BEGADI Universalmagazine Typ 8, G3 HighCap Modification for Schwaben Arms M41 / CA G3 AEG Series

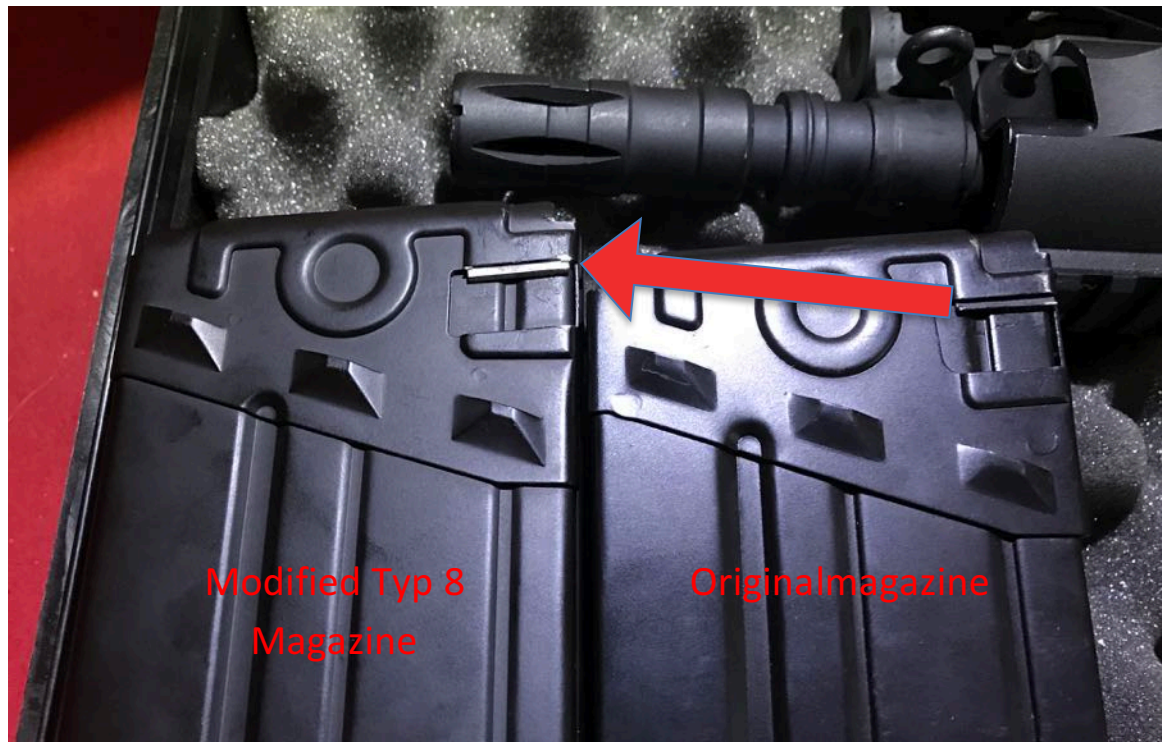
These magazines cause feeding problems in the Schwaben Arms M41 / CA G3 AEG series.

The reason is that the magazines are not pushed far enough into the magazine well.

To solve the problem, a small piece of metal/plastic (for instance of an old magazine case, PC housing, storage boxes, CD) must be stuck in the mag catch window of the magazine. With hit piece installed, the magazine is pushed further into the magazine well and the feeding problem disappears.
